STAFF RECOMMENDATION
1616 Douglas Avenue
December 21, 2016

Application: Demolition; New construction – infill
District: Eastwood Neighborhood Conservation Zoning Overlay
Council District: 6
Map and Parcel Number: 08302018400
Applicant: Kyle Boswell
Project Lead: Melissa Sajid, melissa.sajid@nashville.gov

Description of Project: The applicant proposes to construct a new two-family home.

FIRST FLOOR PLAN

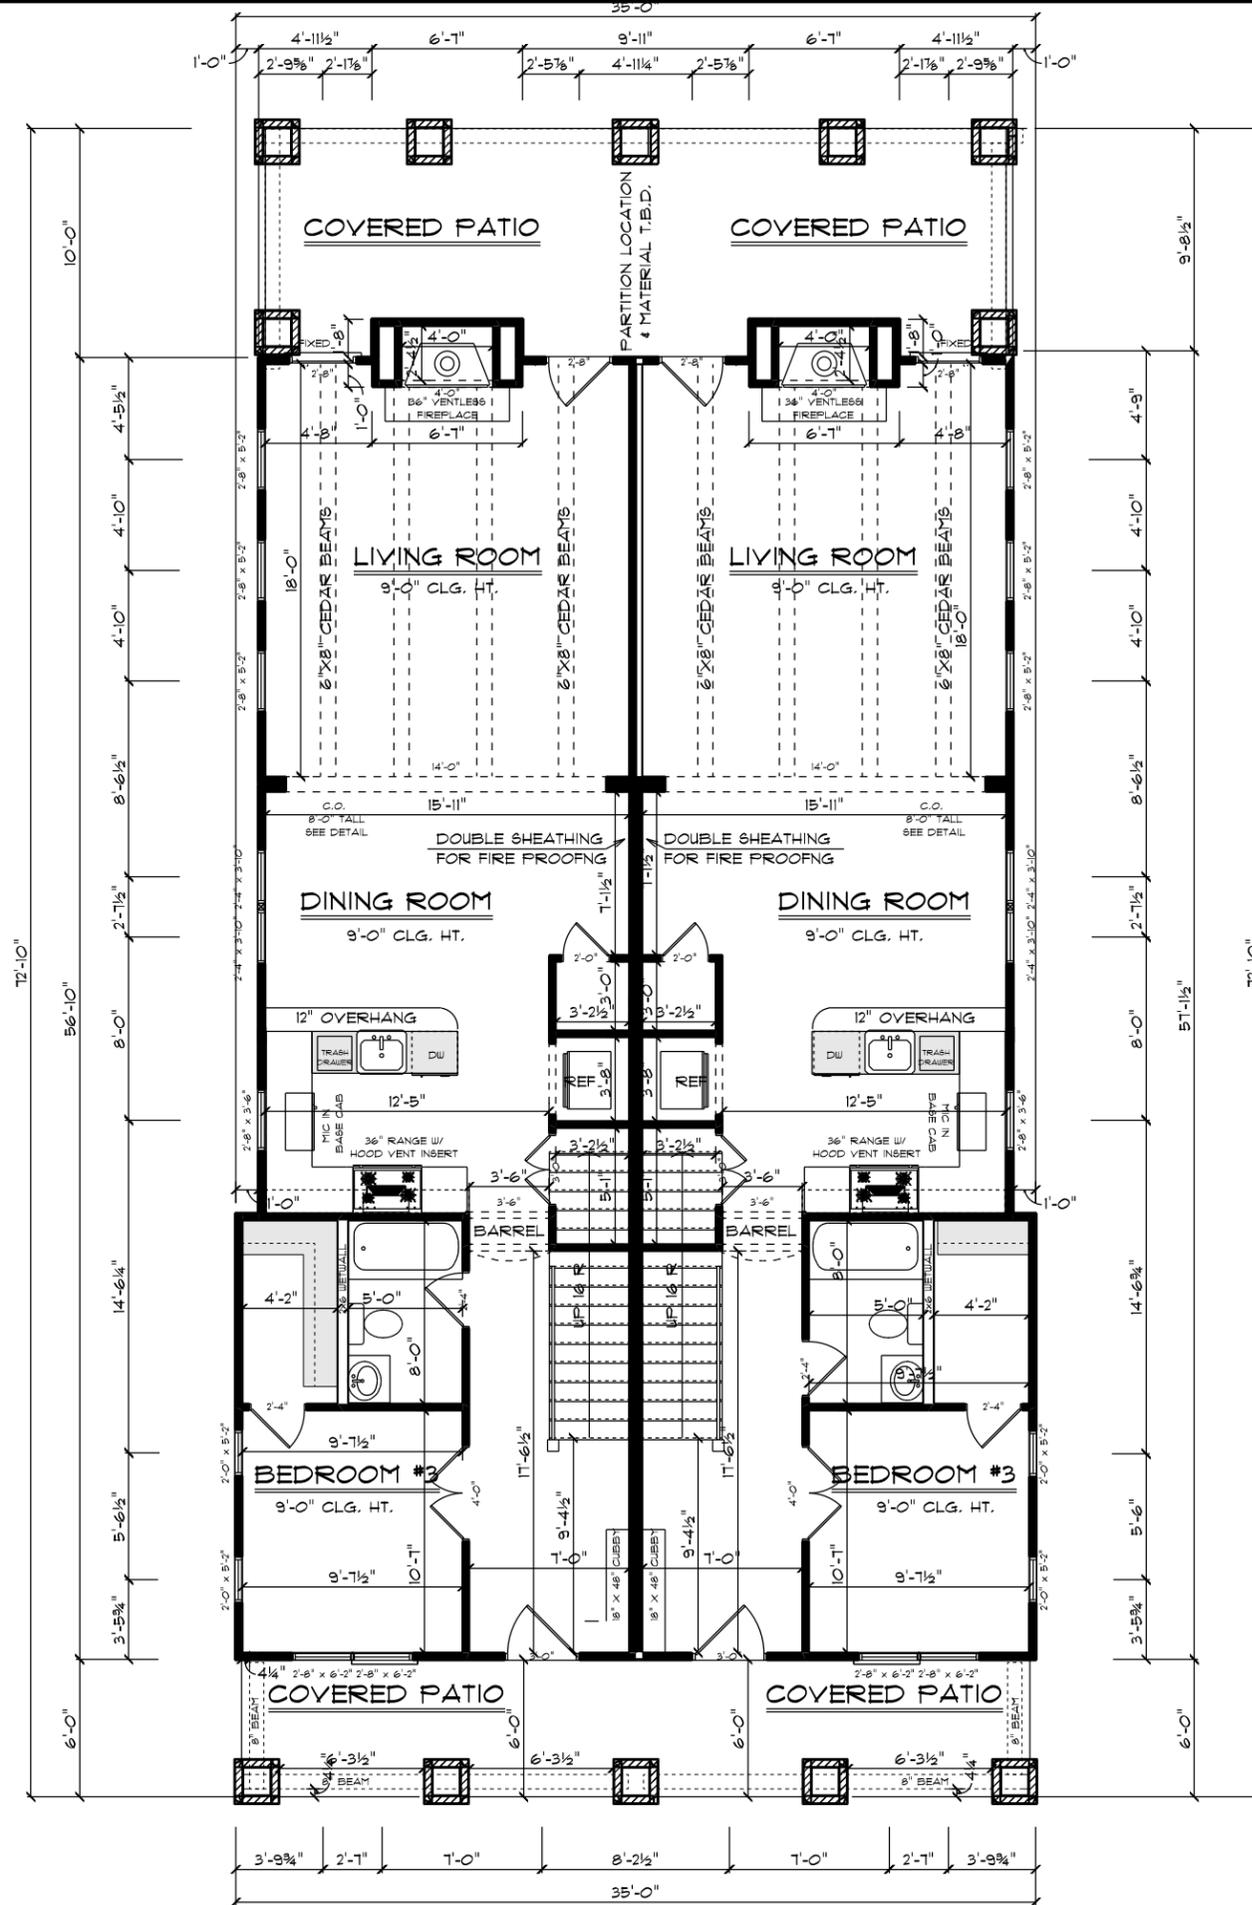
In terms of width, the site plan does not match the floor plans; however, staff believes that the floor plan is the configuration that the applicant is proposing. The proposed building width is thirty-five feet, six inches (35’) at the front, according to the floor plan and narrows to thirty-three feet (33’) approximately nineteen feet (19’) behind the front wall of the proposed infill. Historic buildings in the immediate vicinity range from twenty-six to twenty-nine feet (26’-29’) wide at the front setback

Setback & Rhythm of Spacing: If the proposed infill maintains a width of thirty-five feet (35') wide the entire depth of the building, it would meet the five foot (5') minimum setbacks on both sides. Although the building meets the side and rear setback requirements of the bulk zoning regulations, staff finds that the massing of a building that is wider and deeper than historic buildings in the immediate area will dominate the open space between buildings and would disrupt the rhythm of the established streetscape. The proposed width translates to seven feet, six inches (7'-6") side setbacks while the immediate context ranges from nine to thirteen feet (9'-13') side setbacks.

Front & Rear Elevations
Scale 1/8" = 1'

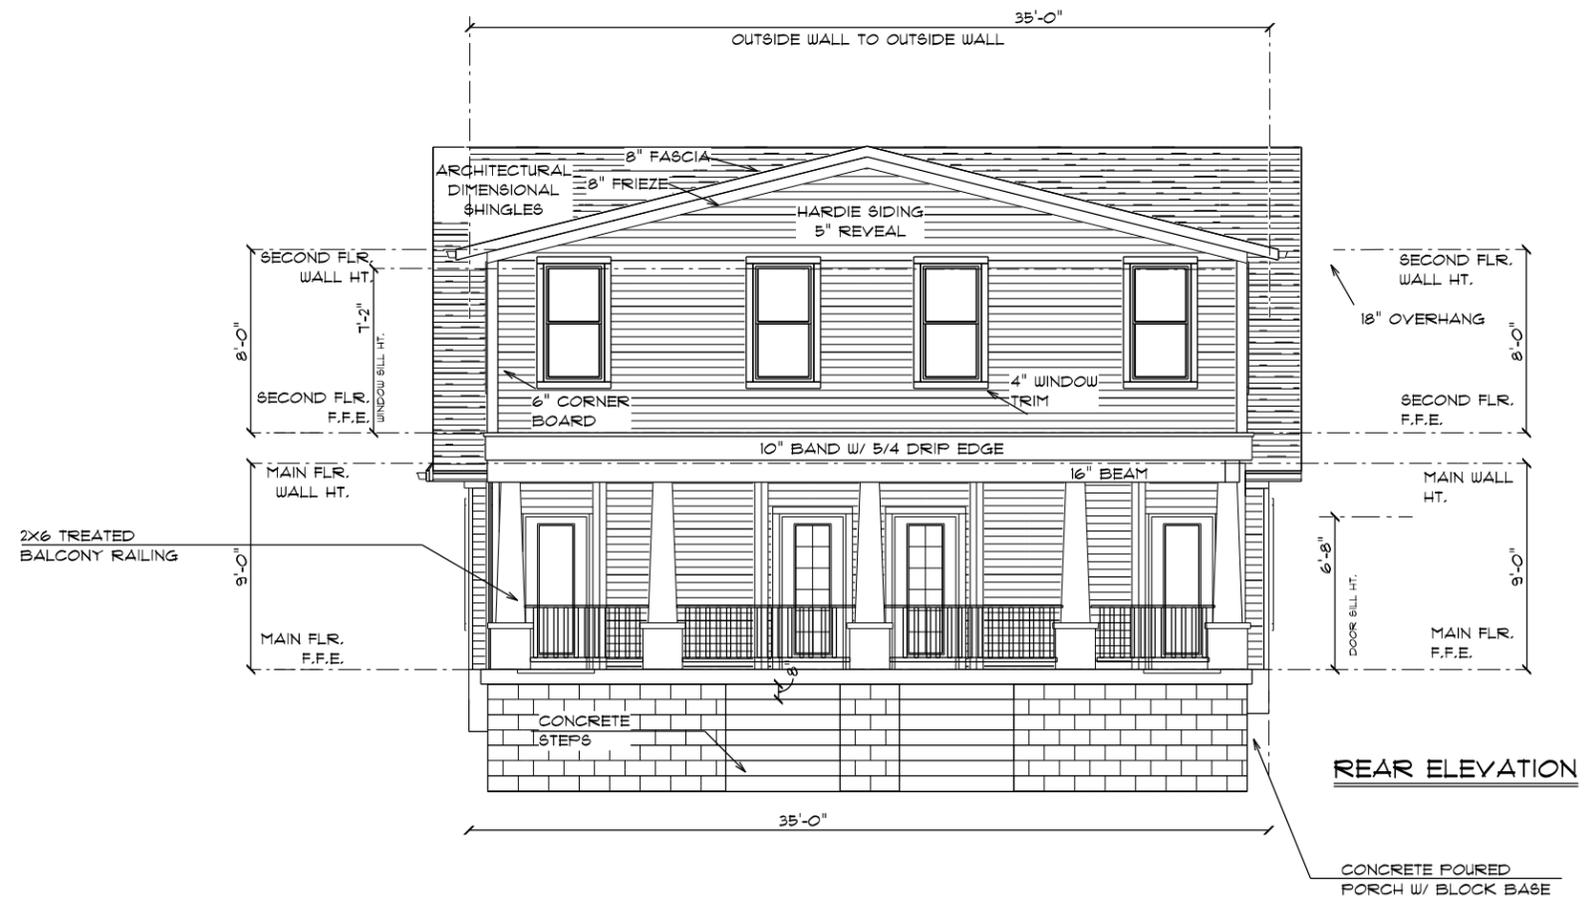
Height & Scale: The proposed infill is one and one-half (1.5) stories at the front with an overall height of twenty-three feet, six inches (23’-6”) from grade. The proposed overall height is slightly taller than historic homes in the immediate vicinity, which includes one and one and one-half story (1-1.5) story homes that range from twenty to twenty-three feet (20’-23’) from grade. The context used was eight homes on the same side of the street to the right that are on similar sized lots. One home was used to the left as after that, the lots are different dimensions and shapes from 1616 Douglas Avenue. The homes to either side, which are on similar sized lots, are twenty feet (20’) tall.

Roof form: The roof will be cross-gabled with pitches of 12:12, 16:12, and 3:12 and includes a shed dormer on the front façade that will be set off the ridge by two feet (2') and two feet (2') from the leading edge of the building. The rear roof form has a pitch of only 3:12 while the design guidelines recommend a pitch of at least 6:12. Staff recommends that a redesign include a minimum of 6:12 for the rear elevation. For this reason, staff finds that the infill does not meet section II.B.e of the design guidelines.

Right and Left Elevations
Scale 1/8" = 1'

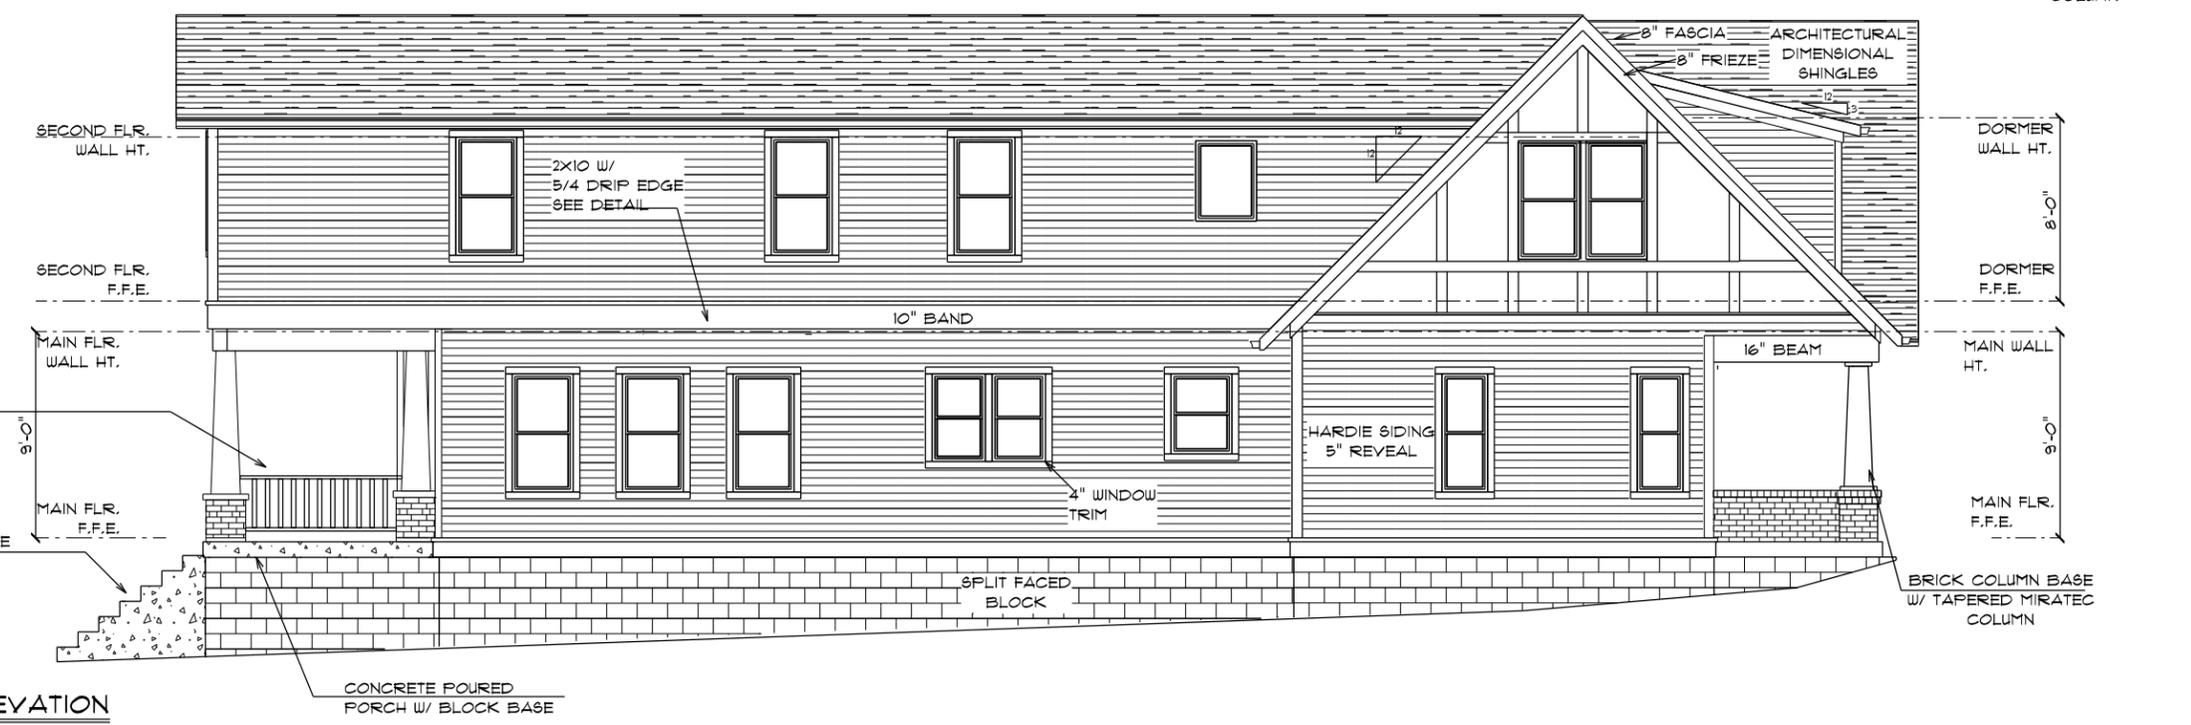
Proportion and Rhythm of Openings: Historic houses nearby typically have windows that are twice as tall as they are wide, with the first story windows larger than the upperstory windows. Most of the windows on the proposed infill meet this proportion. However, there are four windows on both side façades that are located just after the side facing gables that do not meet this proportion. Staff recommends that a redesign include windows that meet the proportions of historic windows. Staff finds the project's proportion and rhythm of openings will not meet section II.B.g of the design guidelines.
